HISTORIC AND DESIGN REVIEW COMMISSION

HDRC CASE NO: 2019-524
ADDRESS: 1818 SAN PEDRO AVE
LEGAL DESCRIPTION: NCB 1863 BLK 3 LOT 1 & 2 W 25 FT. OF 3
ZONING: C-2,H
CITY COUNCIL DIST.: 1
DISTRICT: Monte Vista Historic District
APPLICANT: Sonia Lopez, Maximilion Ramirez
OWNER: Center for Family Relations
TYPE OF WORK: Door replacement
APPLICATION RECEIVED: August 30, 2019
60-DAY REVIEW: October 29, 2019
CASE MANAGER: Stephanie Phillips
REQUEST:

The applicant is requesting a Certificate of Appropriateness for approval to replace two existing Victorian-style wood doors on the front façade of the primary structure with new steel doors

Door Replacement

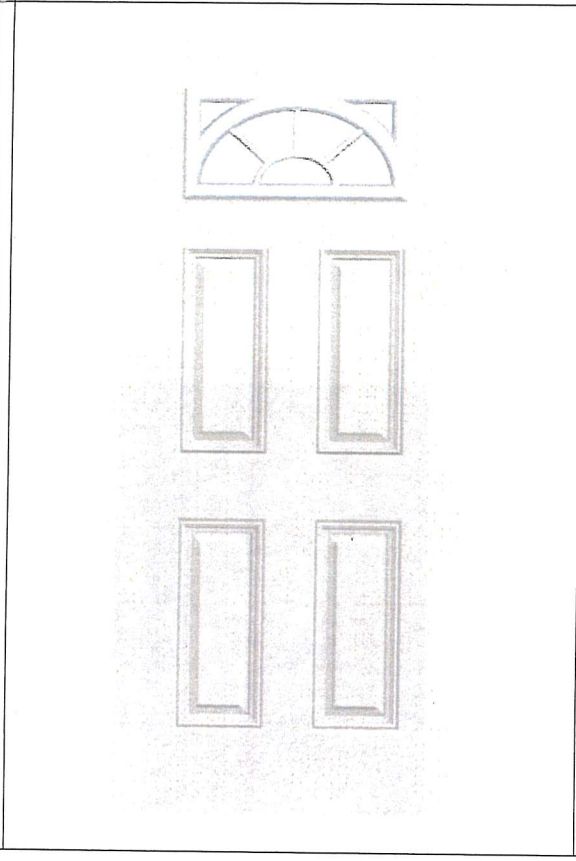
- b. **DOOR REPLACEMENT-** The applicant has requested to replace two existing front doors on the primary façade. The applicant originally submitted a Certificate of Appropriateness request for the replacement of one of the two doors. Upon review of the documentation, staff discovered that a second wooden front door had already been replaced with a new steel door. One of the doors is the primary front door off of E Craig Pl, which has already been replaced. The second door is a secondary entrance to a 1-story mass, set back from the front façade, but is visible from the public right-of-way on E Craig Pl. The doors are made of wood and feature an elaborate Victorian-era design, including carved or applied organic detailing and a shelf under the main single glass pane. According to the Guidelines, existing doors should be repaired and preserved. Staff does not find the replacement steel doors appropriate. Staff finds that the doors should be repaired.

Staff does not recommend approval based on findings a and b. Staff recommends that the doors be repaired and retained.

If a door is deemed irreparable by the HDRC, staff recommends that the applicant installs two new fully wooden doors of a similar style that are compatible with the historic structure. A specification is required to be submitted to staff for review and approval prior to receiving a Certificate of Appropriateness.
